## **Addendum Number One**

**Date of Issue:** 02/22/13

**Project:** USC Preston College Bathroom and Flooring Renovations  
Project Number: H27-6086-SG

**A502**

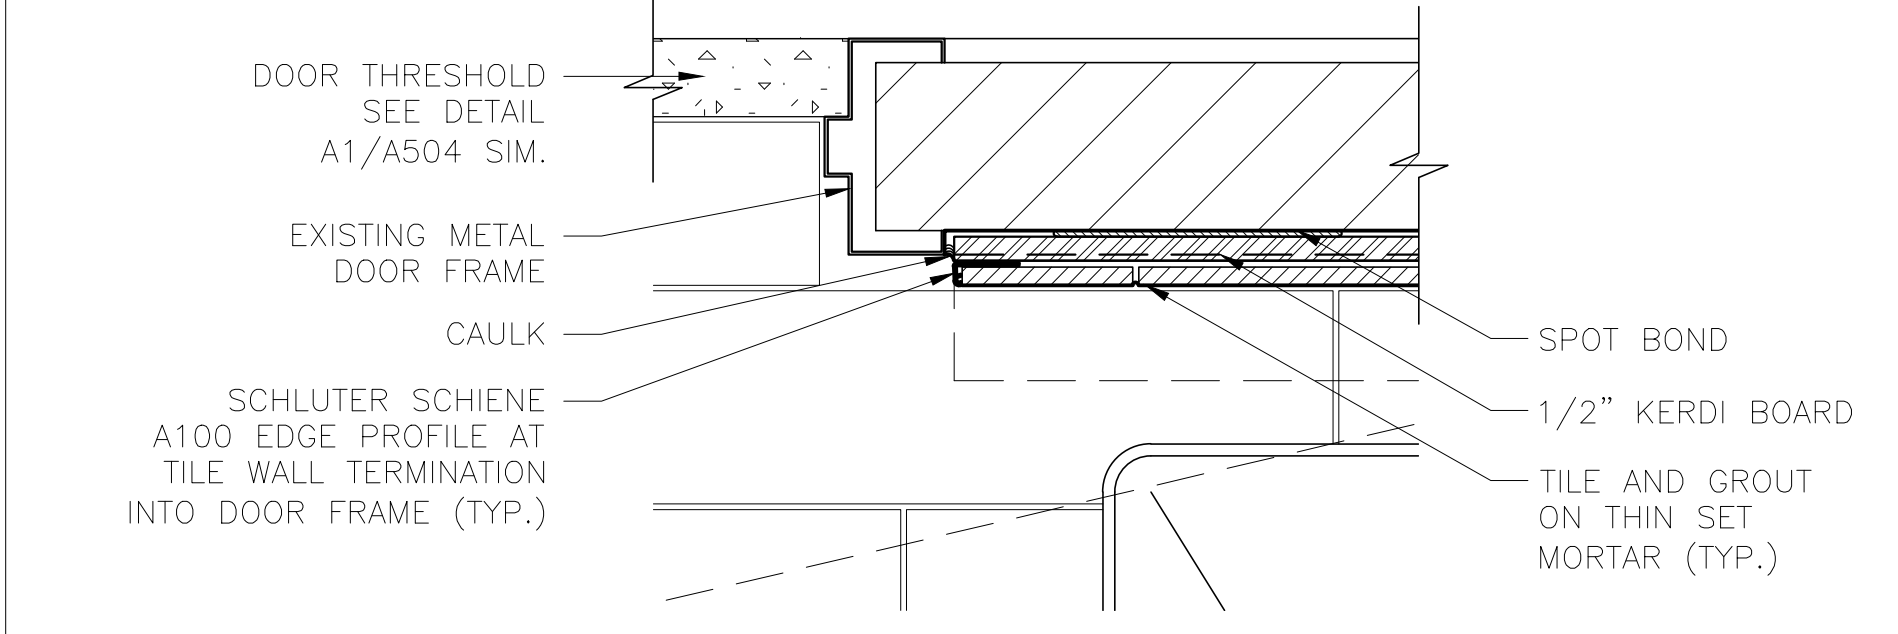
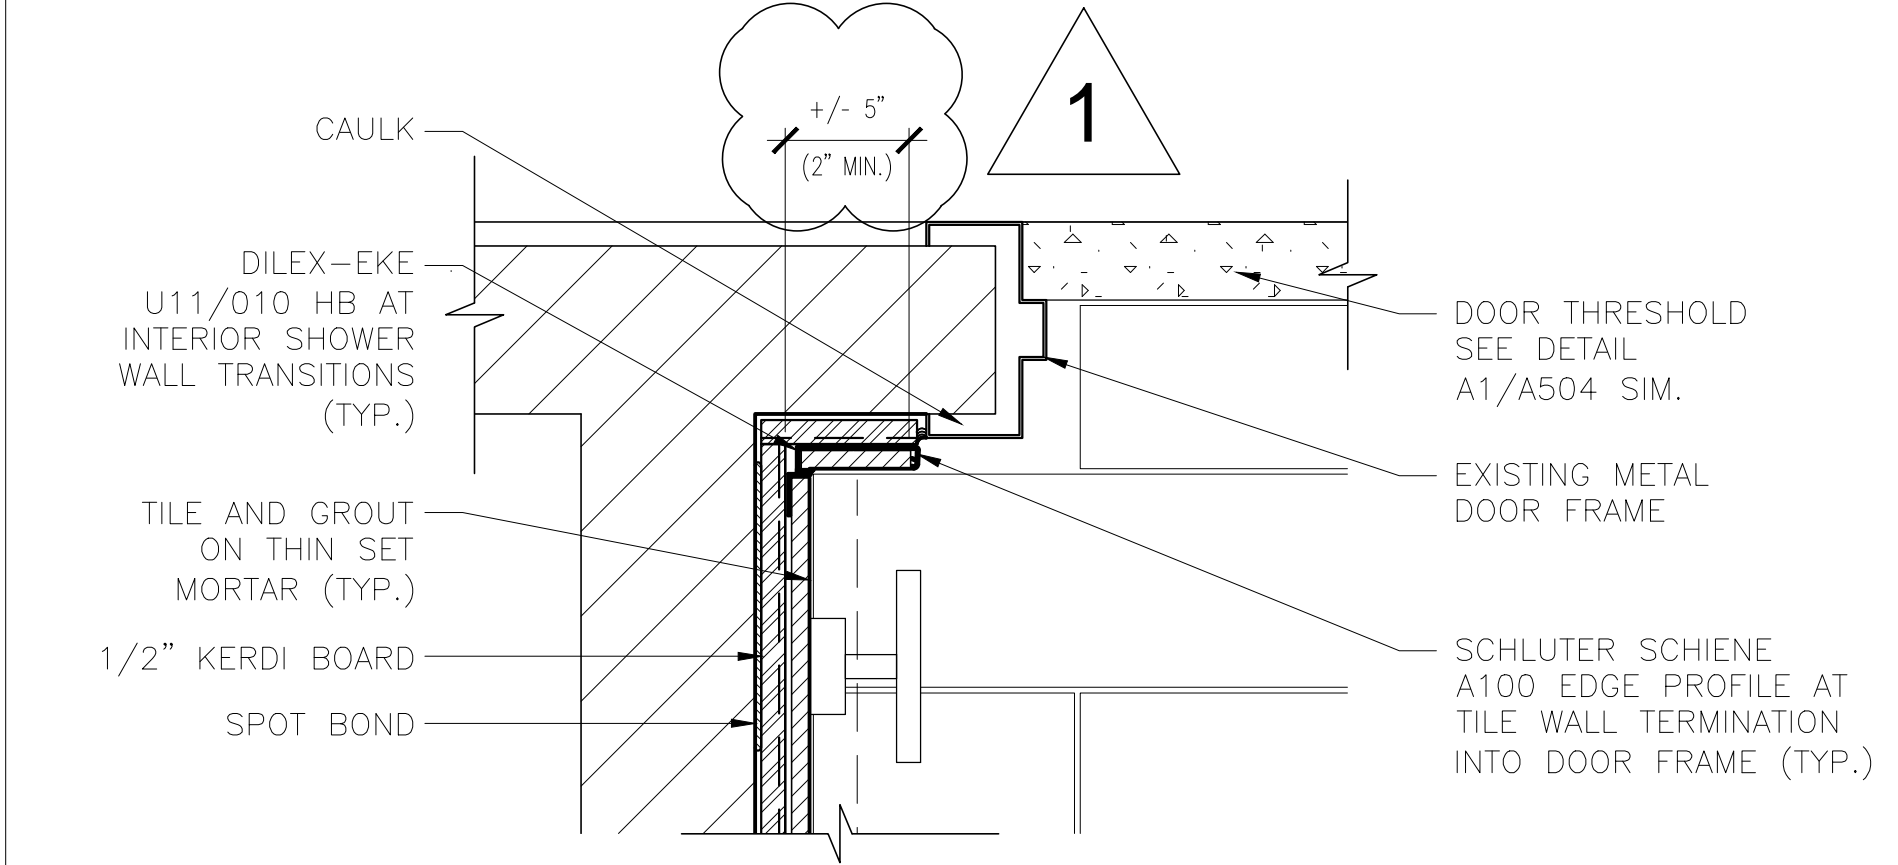
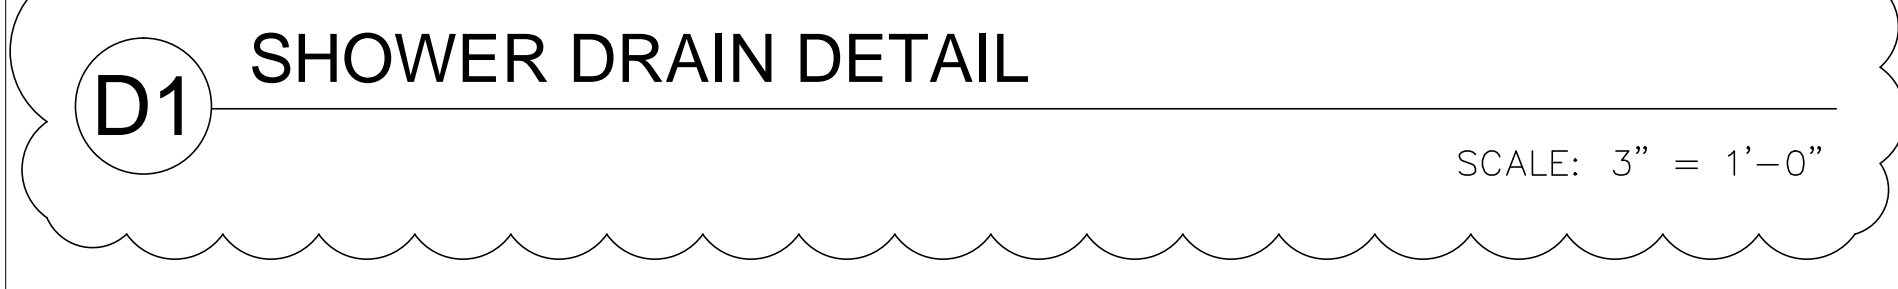
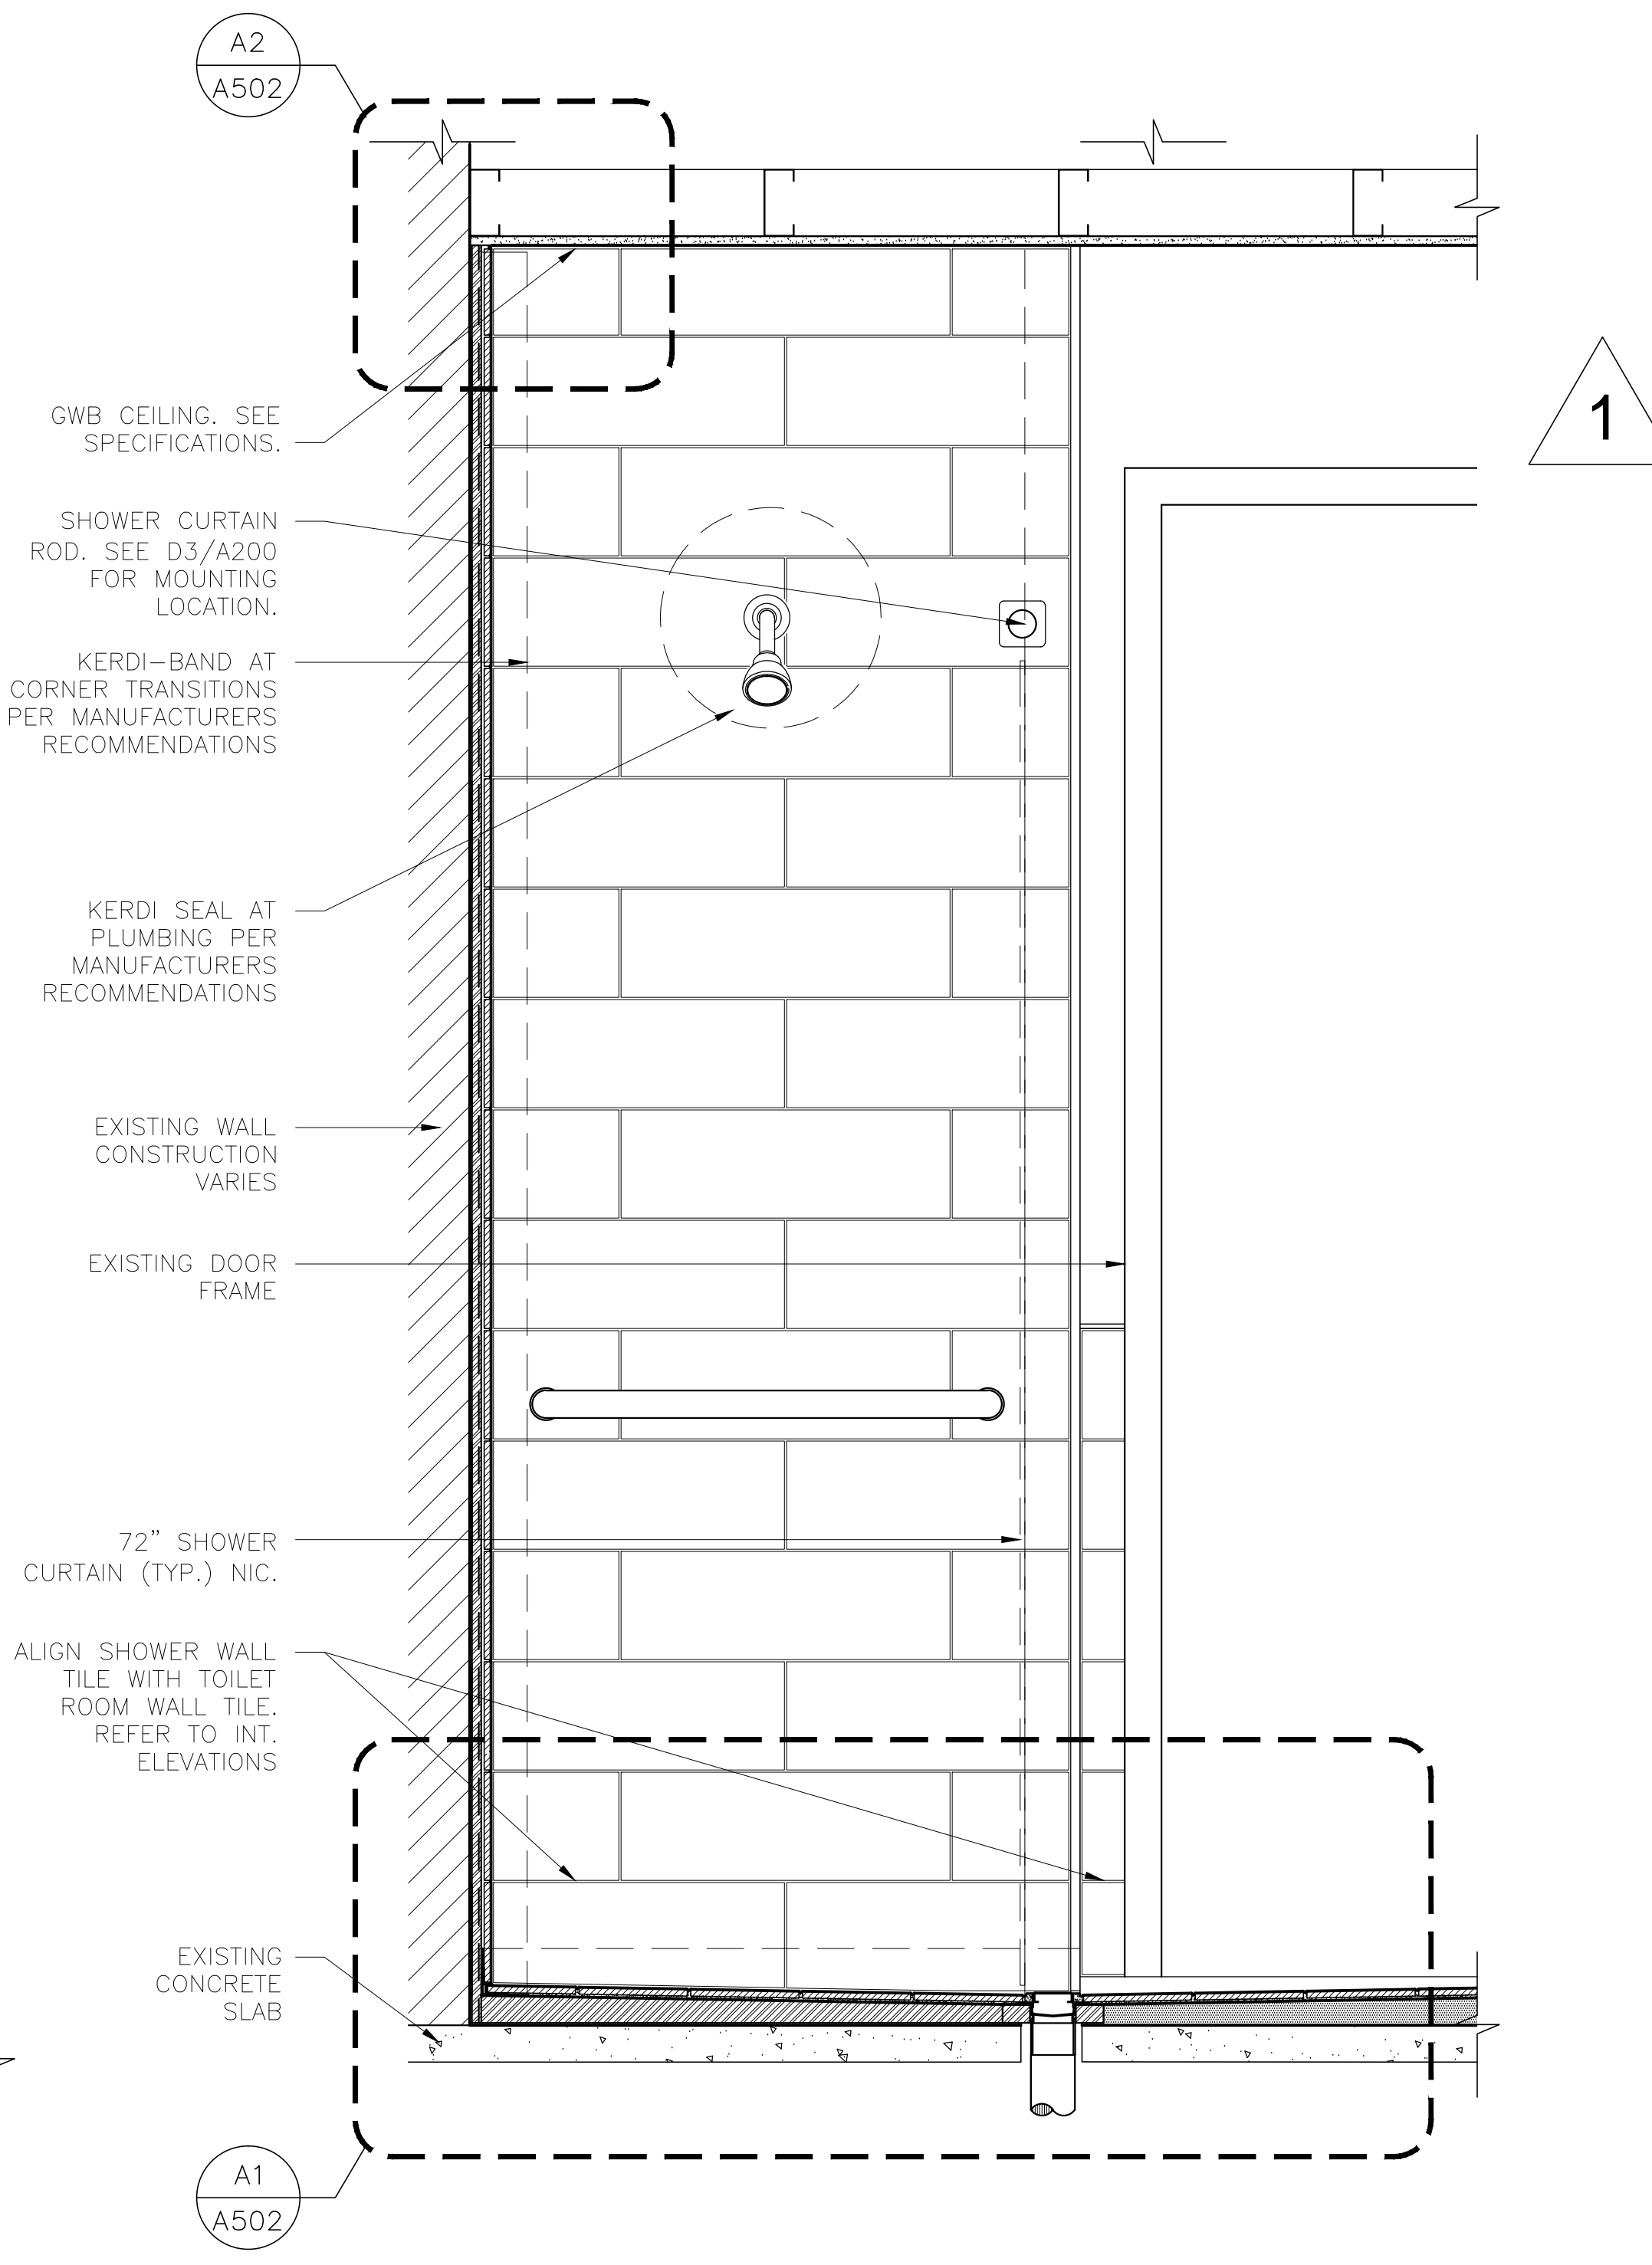
24. **SHEET A500** Delete A1/A500 and add Sketch SK-A-004.
25. **SHEET A501** Delete B1/A501 and add Sketch SK-A-005.
26. **SHEET A502** Remove and replace with enclosed sheet A502.
